RE: **Zone Map Amendment** – Change Zoning District from SS to PUD
Final Development Plan Modification to PUD – Chick-Fil-A
Application Number: 20230739

Chick-fil-A
501 East Kemper Road
Modification to a PUD and Zone Map Amendment
Application# 2023-0739
November 14, 2023

CHICK-FIL-A
501 E. KEMPER ROAD
PLAN REVIEW APP # 20230739
19020115
NOVEMBER 10, 2023

PLANNING COMMISSION
ENGINEERING REVIEW

SHEET NUMBER
L-100

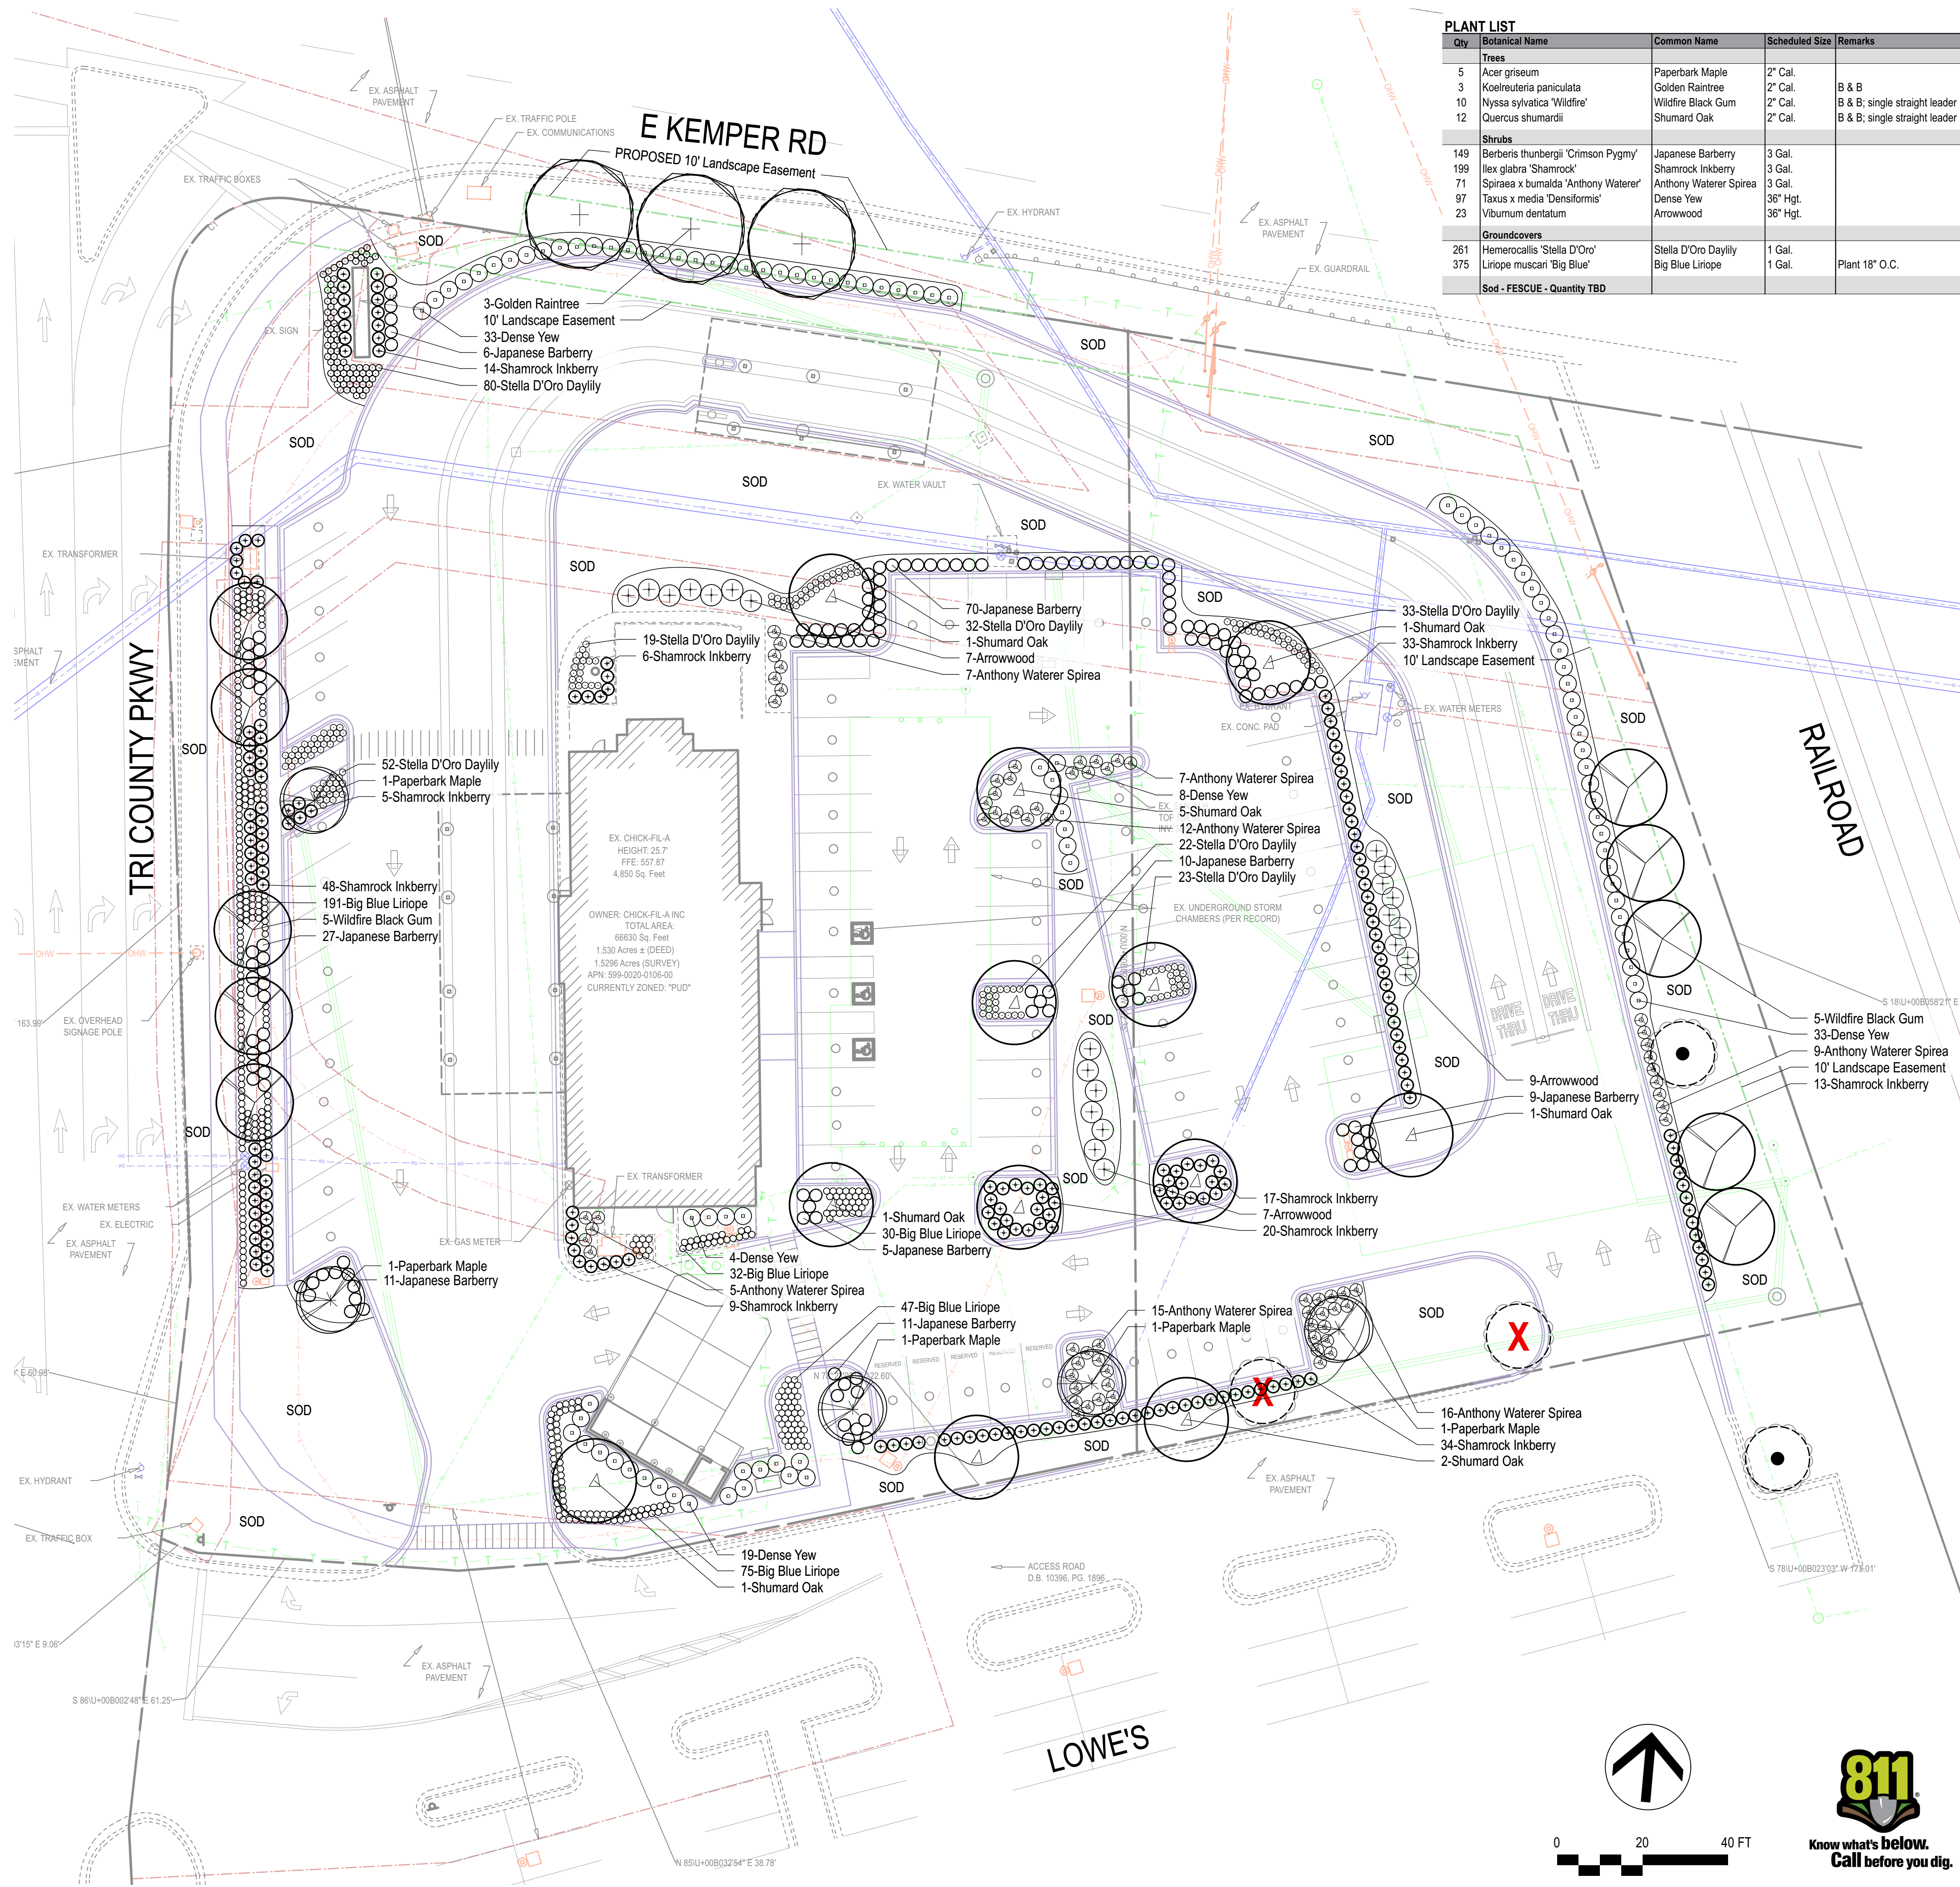
- 8) A landscape plan was submitted to which staff has the following comments:
 - A) There is no Landscape Plan uploaded in this latest submission. The Landscape Comment response letter, dated 10.30.2023, states bufferyard plant quantities were updated, however there is no plan.

- B) The Landscape Comment response letter states that a tree survey is forthcoming and existing tree locations were temporary added to the Plan based on Google Maps imagery. The plan set needs to accurately identify all the trees are their current size to be removed even if they were planted as part of the recent site improvements.

- C) Plant diversity is provided, however the plant quantities should be spread equally amongst the different species. Shrub quantities need to be more equally divided.

The Applicant requested clarification on the requirement in the code. Plant material diversity, with even distribution, is required per Section 153.403 (E).

- 7) The Landscape Plan be revised per staff comments.
- 8) The relocated waste enclosure will comply with all the requirements of Section 153.254 (G).

SHEET SITE PHOTOMETRICS

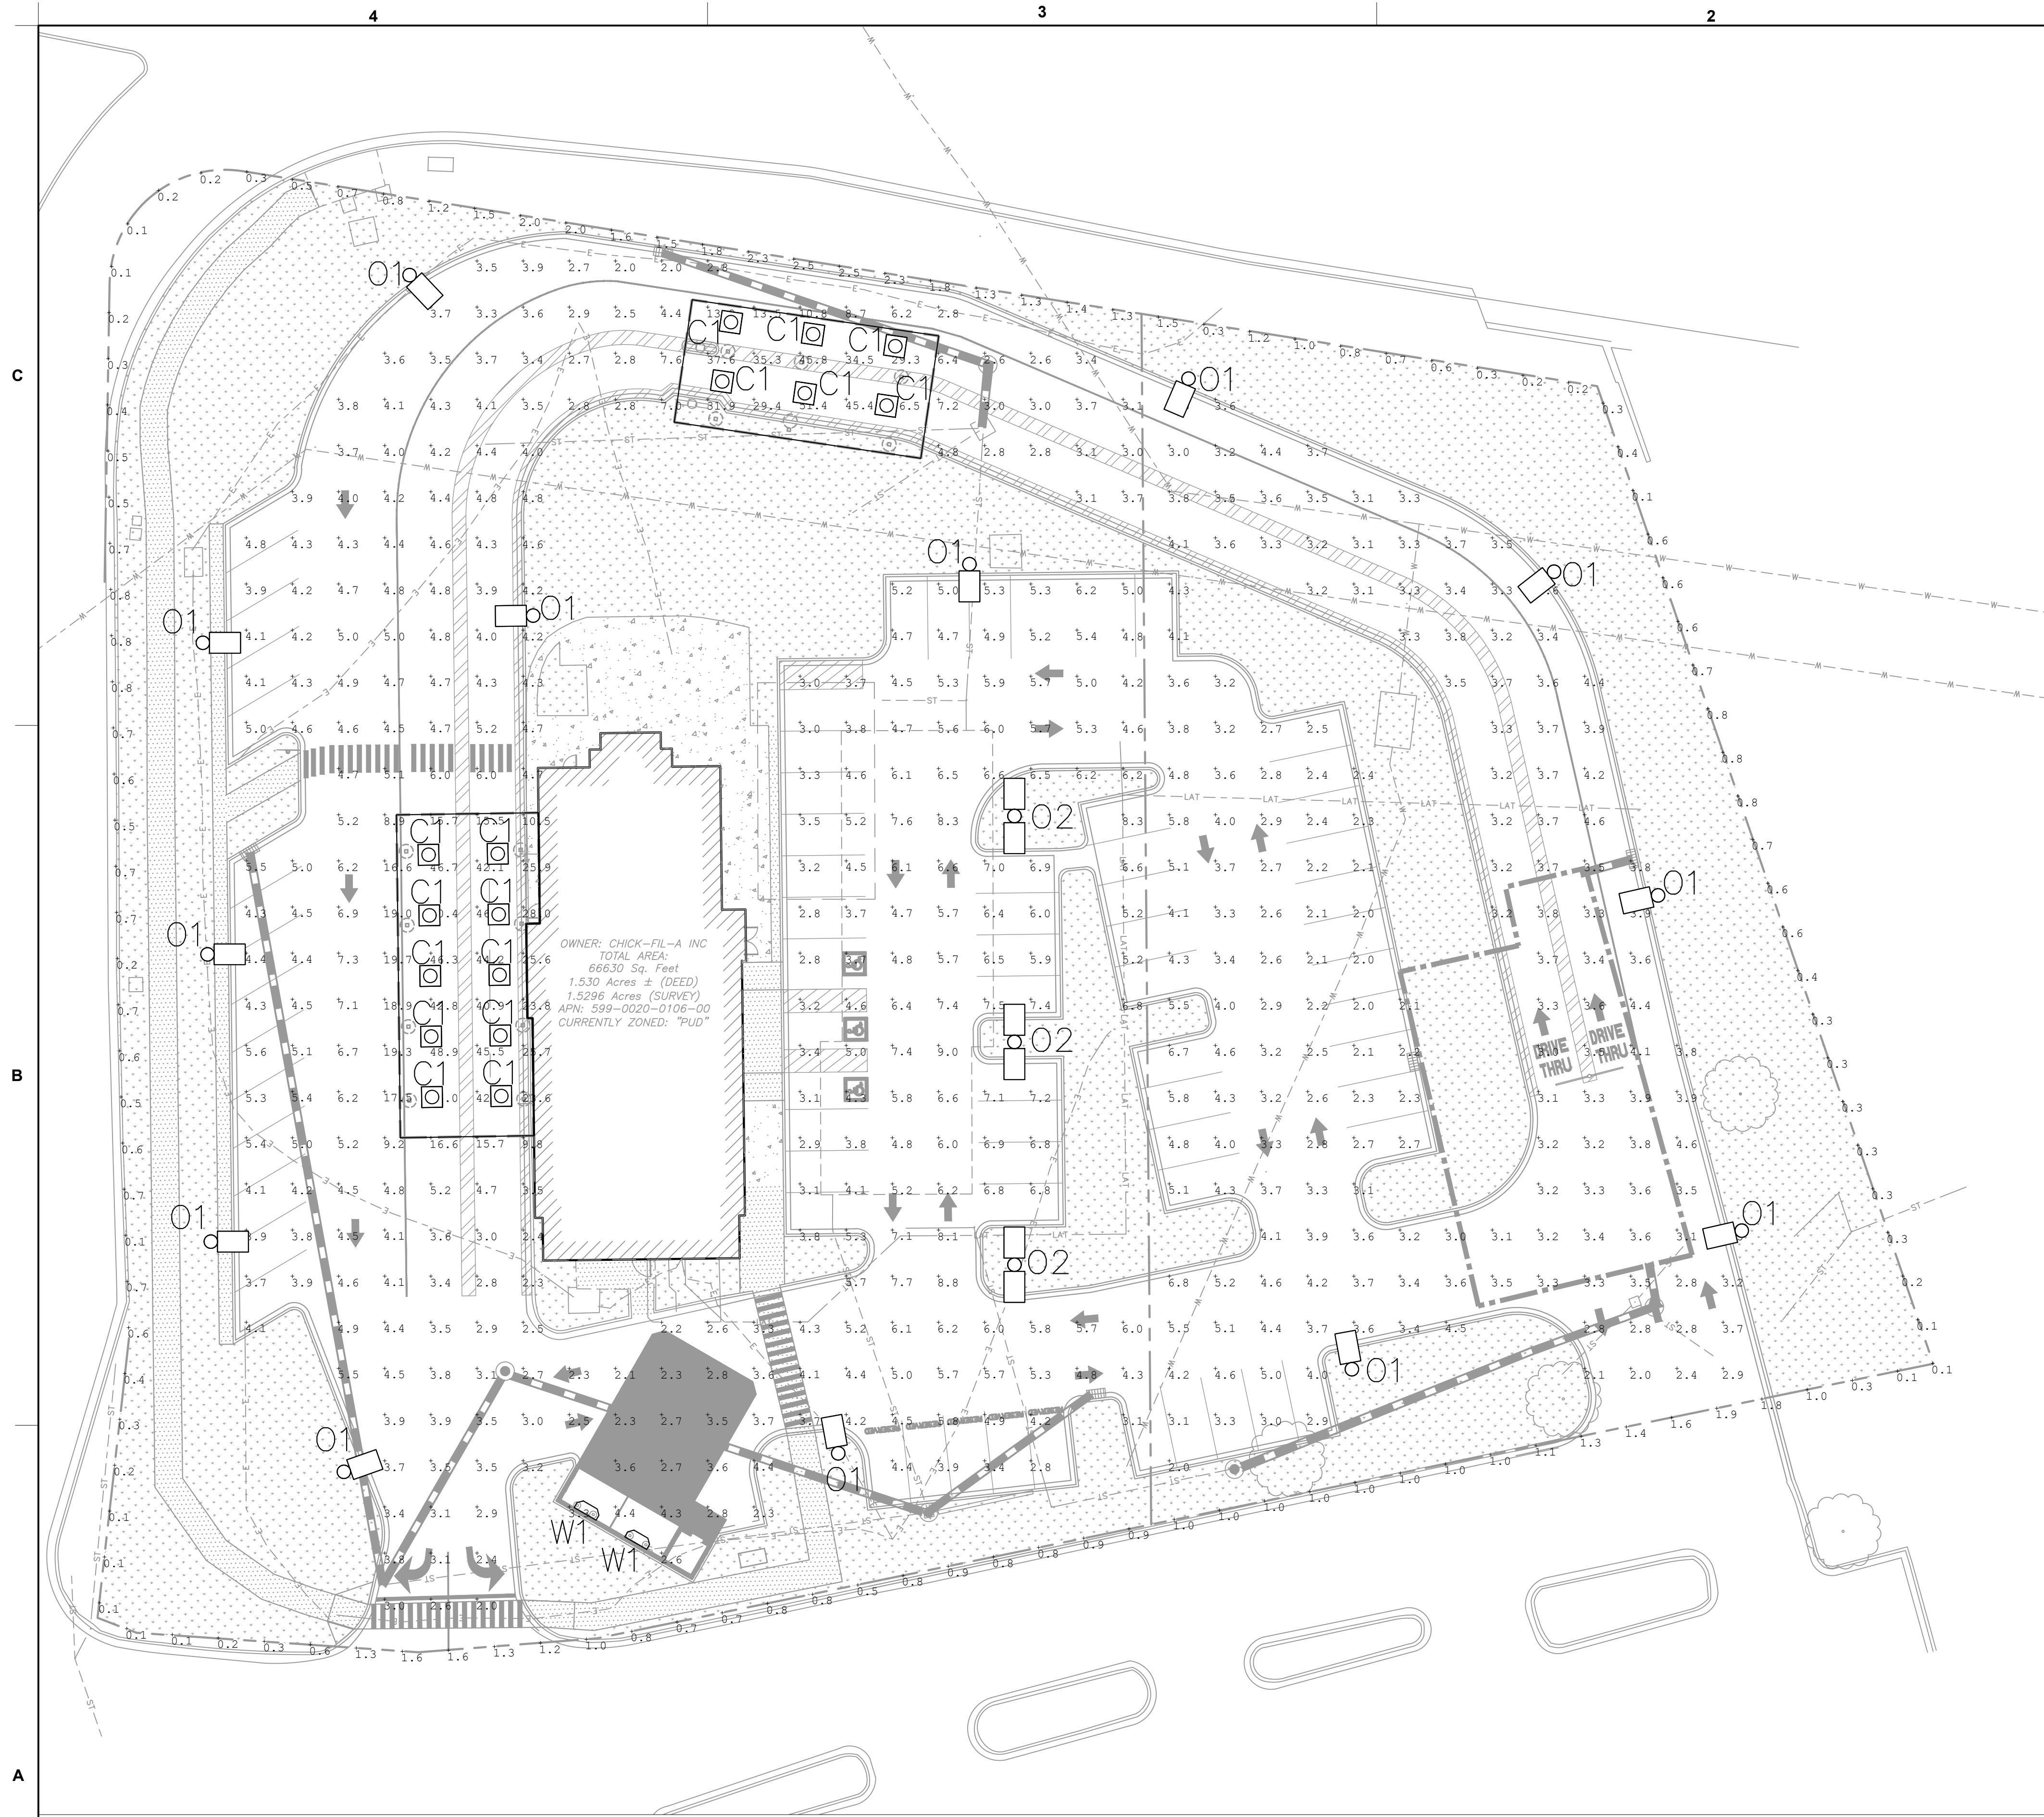
- C. All lighting and re-lamping of the existing fixtures shall conform with the existing codes to the City of Springdale. Special lighting fixture conditions regarding the canopy: Canopy lighting shall be reduced to a medium use from two to ten max illumination.

- 9) There are no modifications to the existing building, building or free standing signage.
- 10) Planning Commission needs to determine if the proposed photometric lighting plan is appropriate in terms of light levels. All fixtures and poles are to be a dark non-reflective color.

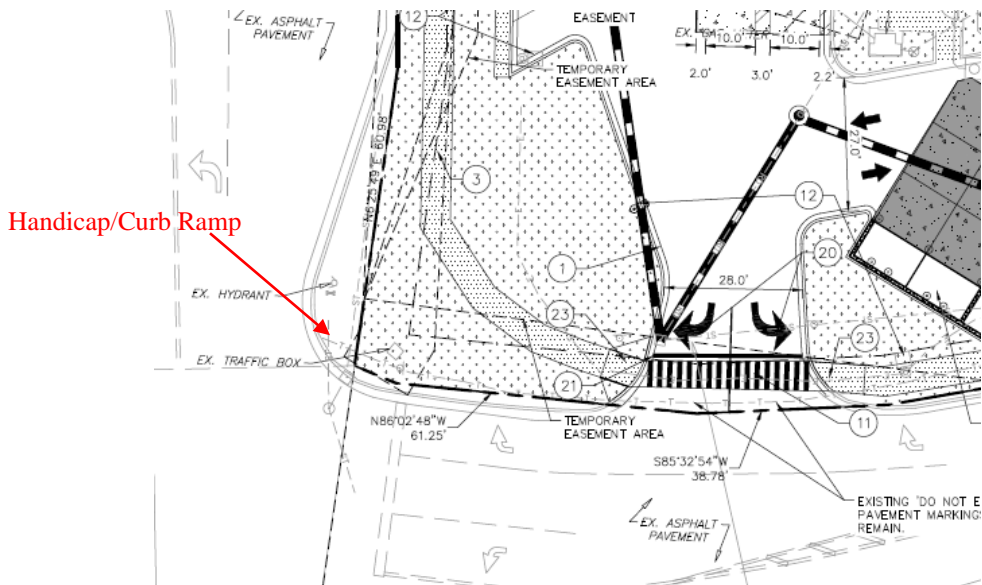
1. The sidewalk tie-in shall be revised to better align with the existing ramp. The sidewalk at this location may need to be wider and located at the back of curb. The submitted site plan dated October 30, 2023, noted that the proposed connection to the existing curb ramp is to be finalized in the construction drawings.
2. The site plans shall also be revised to extend the sidewalk to the curb at the shared entrance drive along Tri-County Parkway and construct a handicap/curb ramp. The curb ramp shall be oriented for a future ramp to the south crossing the shared entrance roadway.

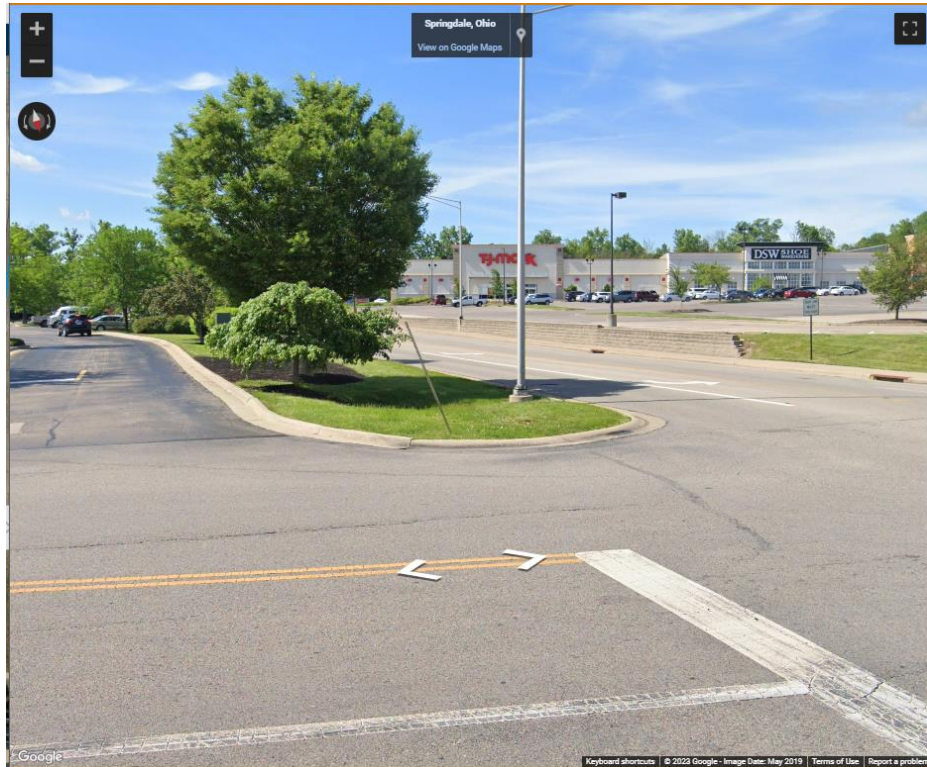
7. There is a concern with the site distance at the intersection of the at the shared entrance drive along Tri-County Parkway. It is recommended that the applicant coordinate with the adjoining property owner to the south to improve the situation.

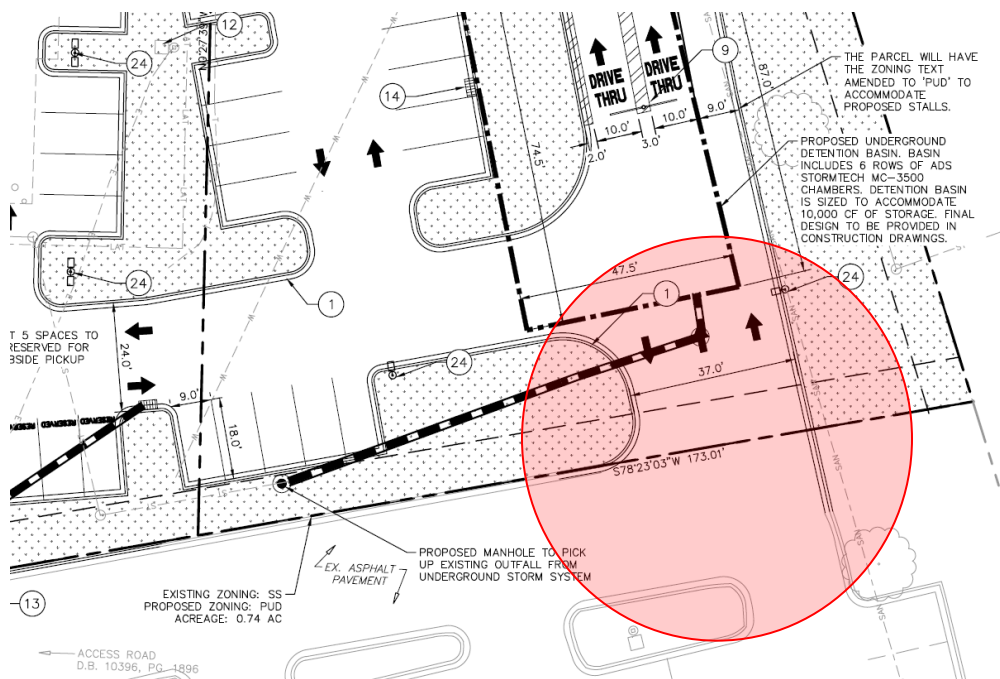
8. It is recommended that the western entrance be reduced to two lanes (entrance lane and exit lane).
